LANDSCAPE VEGETATION MANAGEMENT SUB PLAN

Moorebank Precinct East Stage 2

Author	[REDACTED]	_____
Contributor	[REDACTED]	_____
Approver	[REDACTED]	_____
Report No	SSS2-QPMS-EN-APP-00035	
Date	13/10/2022	
Revision Text	009

DPE review comments - Condition B141(a) Landscape Vegetation Management Sub-Plan

Date **16.12.20** Job Number **20171017** Drawn **MC** Checked **RL** Drawing Number **UDLA-02**
 Project **MPE Stage 2 - Area 1 Precinct Moorebank Logistics Park, Moorebank NSW**
 Scale **1:500 / A0**
 0 5 10 20 30 40 50m
 Rev **K**

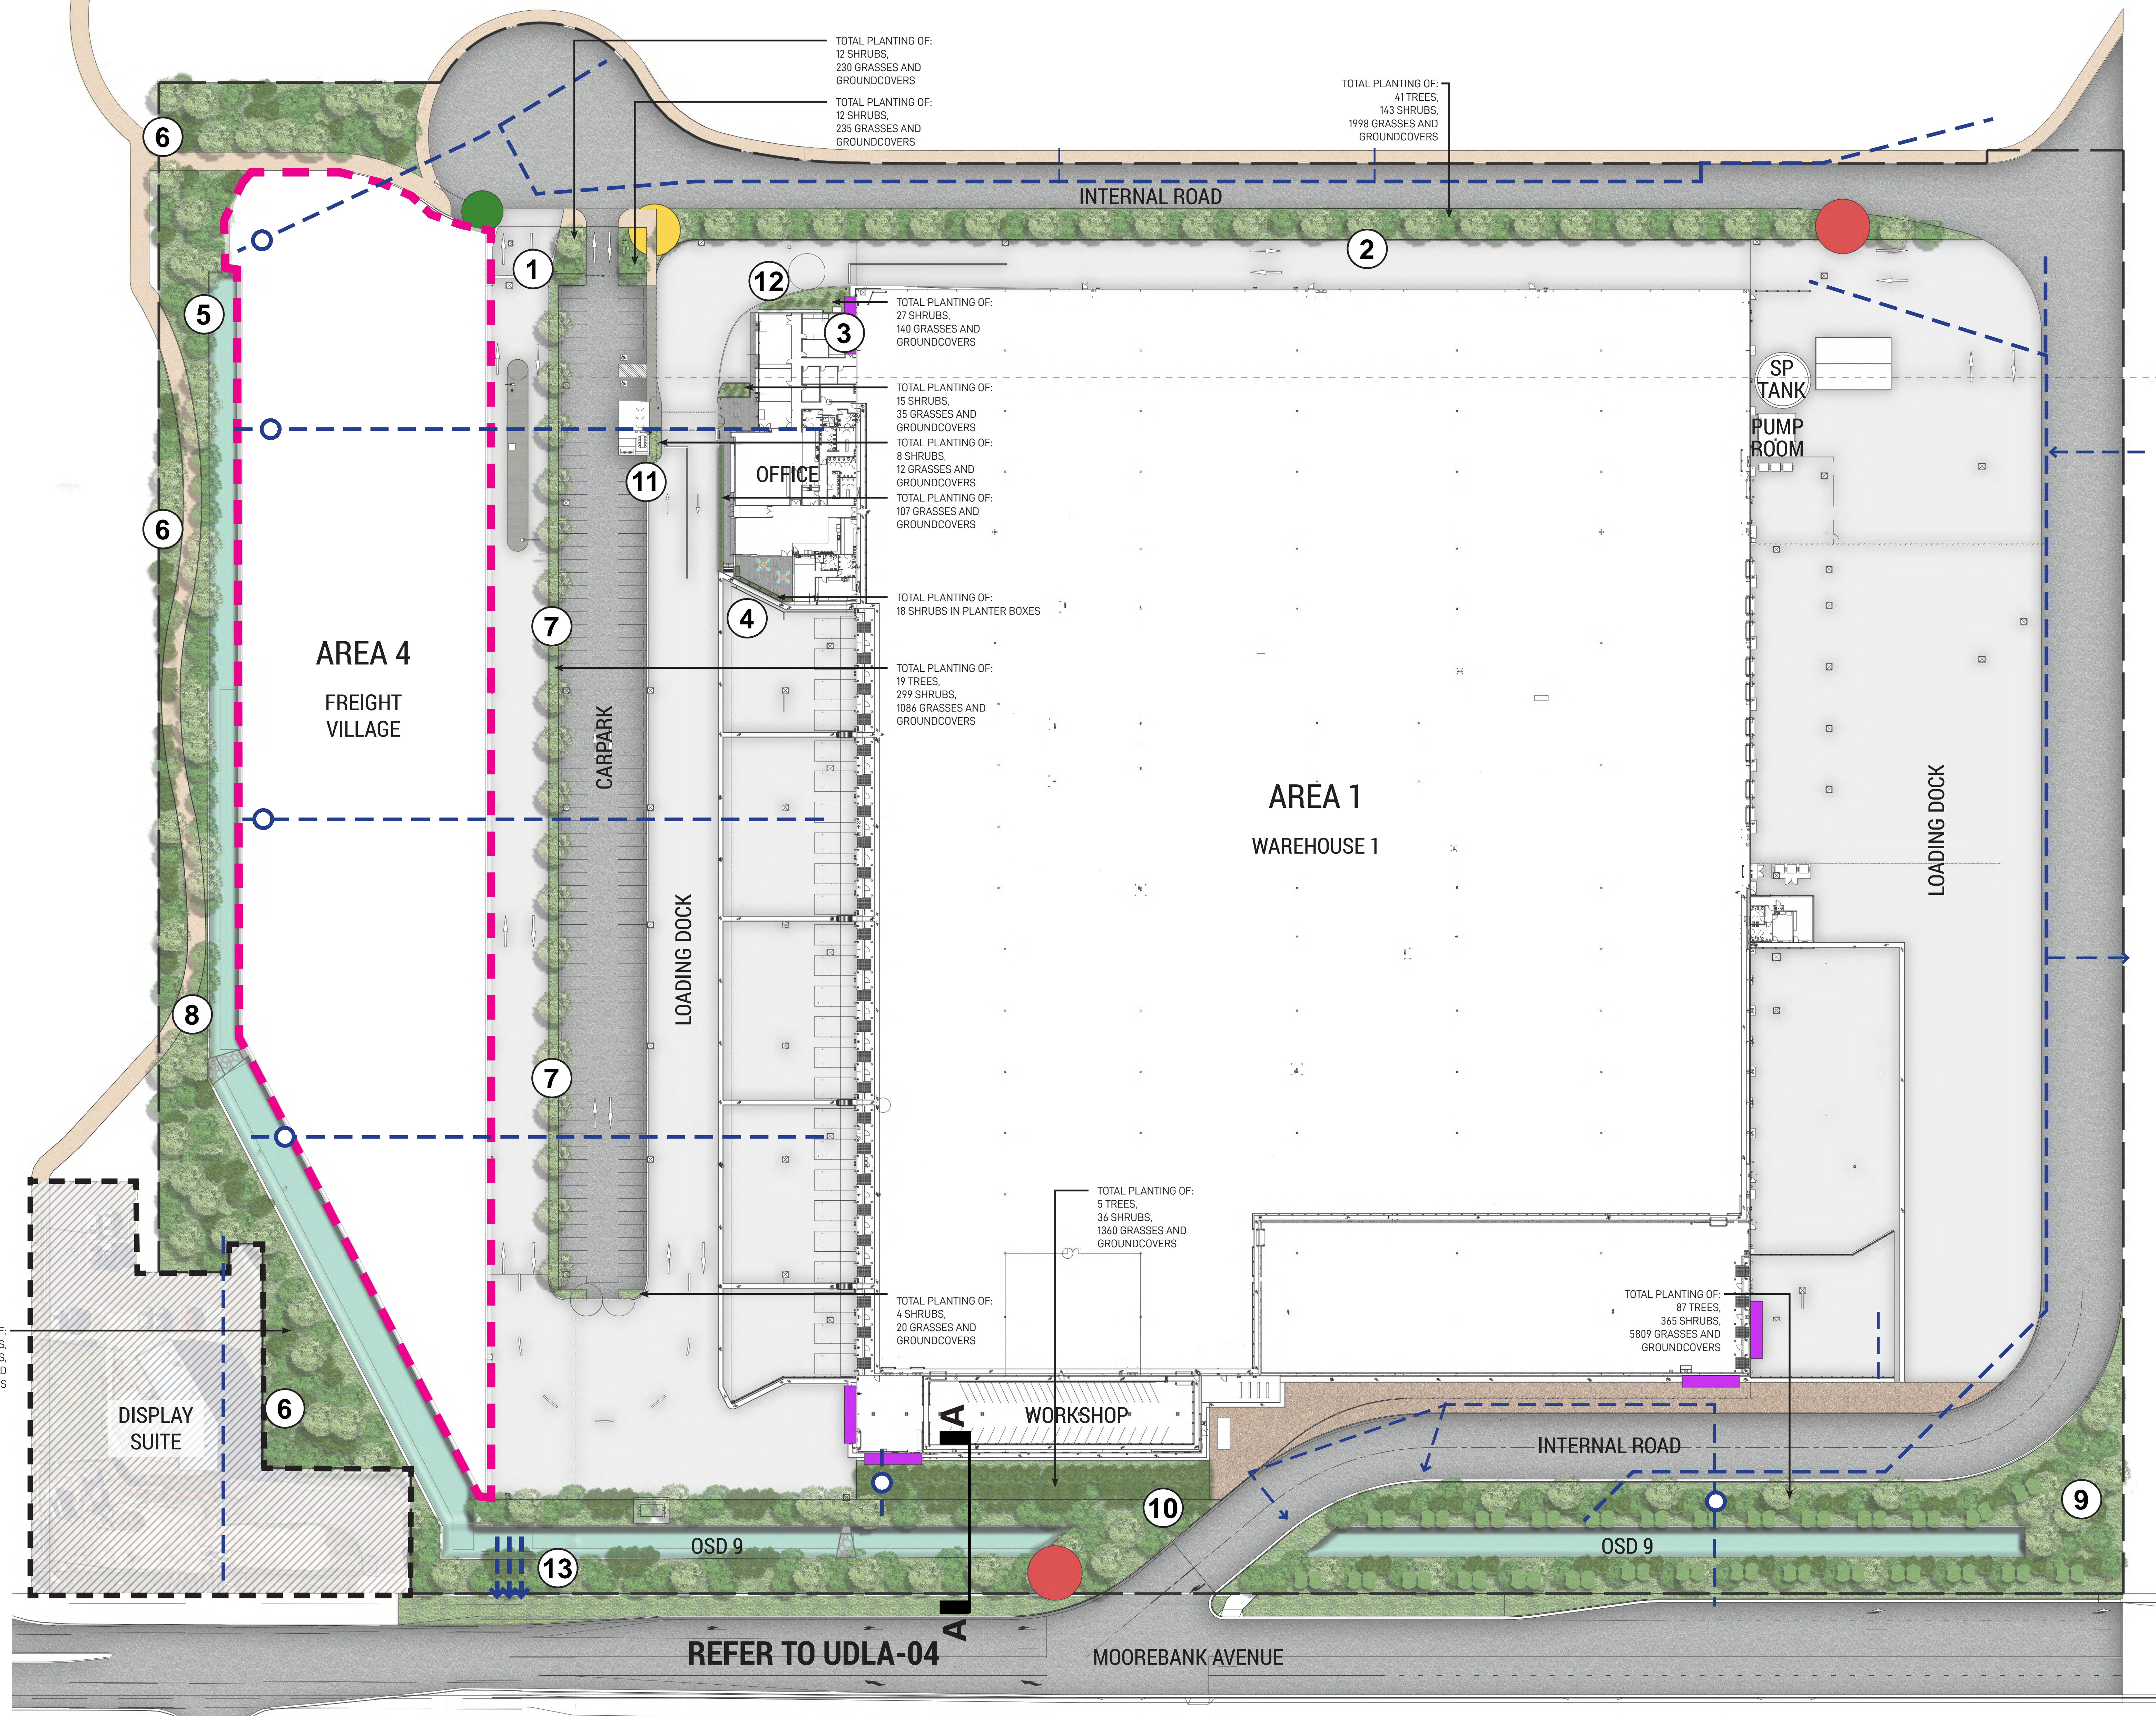
- Appendix A2 Landscape Drawings – comprises Area 1 Masterplan
Note: The legend states '1 Proposed Mix of native grasses on lid of OSD lid planter box', which is inconsistent with the latest submission of the UDLP for Area 1.
- Appendix B Area 2 – cover page - included
- Appendix B1 Evidence of Consultation – includes DPIE initial review comments and Proponent response & notes GANSW comments not yet rec'd – this is included in above table
- Appendix B2 Landscape Drawings – included
